**From:** Mark Marion  
**Sent:** Thursday, October 21, 2021 9:29 AM  
**To:** Ryan Clegg; Sophie Kiepe; Bryan Lohoff; Brian Vickers  
**Subject:** FW: Pike Solar Layout near Williams Creek

**From:** Mark Marion [<mailto:MMarion@juwiamericas.com>]  
**Sent:** Thursday, July 02, 2020 2:12 PM  
**To:** Jessica Davis <[jedavis@csu.org](mailto:jedavis@csu.org)>  
**Cc:** Steve Ihnot <[sihnot@juwiamericas.com](mailto:sihnot@juwiamericas.com)>; Joe Awad <[jawad@csu.org](mailto:jawad@csu.org)>; Mike Francolino <[mfrancolino@csu.org](mailto:mfrancolino@csu.org)>  
**Subject:** Pike Solar Layout near Williams Creek

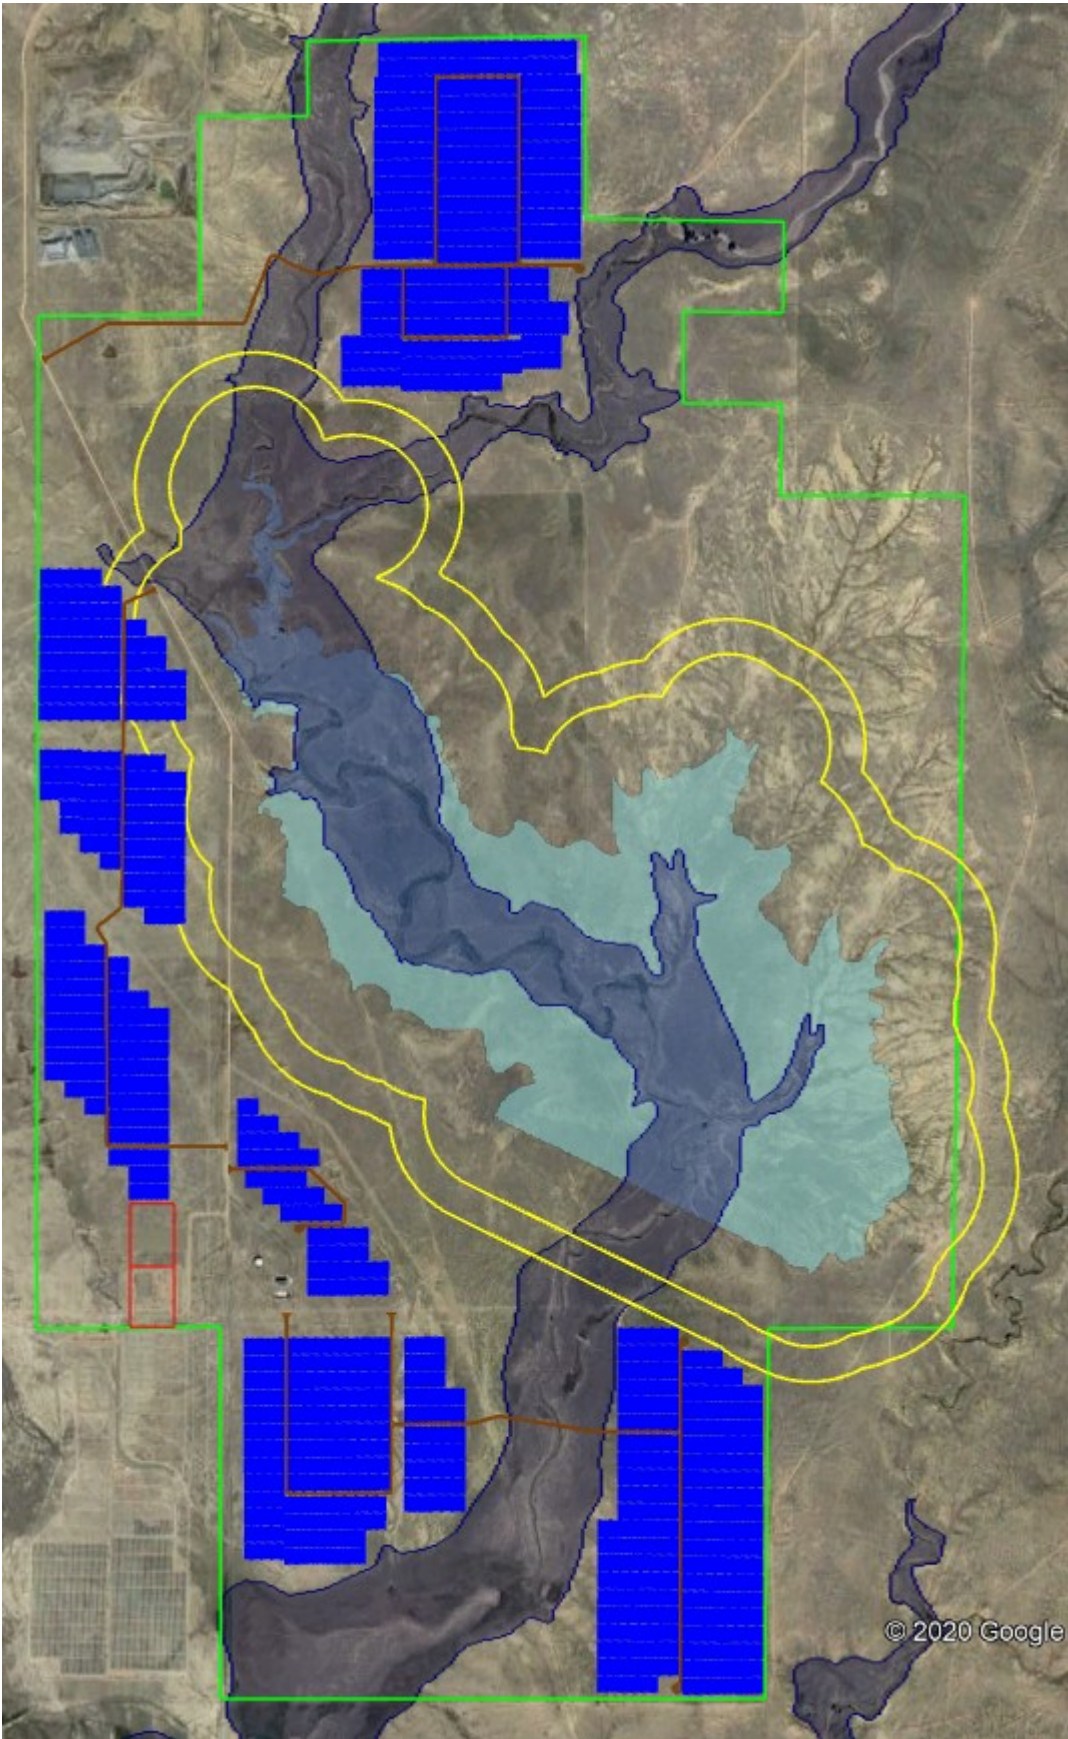
Hi Jessica, thanks for your patience as we've revised our layout considering what you mentioned to me about the future development of the site. The image below shows the layout of the solar and battery project we propose. The legend is as follows:

We had to design inside the 1,000' buffer just a bit on the West side. I'll point out that the project remains to the West of (1) the access road and (2) the existing Tri-State and CSU transmission corridor. We reasoned that there is already existing infrastructure encroaching on the setback, so the solar encroachment is acceptable. How does this layout look to you? Ultimately we're looking to you/CSU for an approval on the layout so we can finalize the lease and begin necessary site studies.

Good afternoon. I hope you are doing well. I checked with my stakeholders and they are comfortable with your updated map. I have no objections to your proposal for placing solar panels in the places that you have depicted.
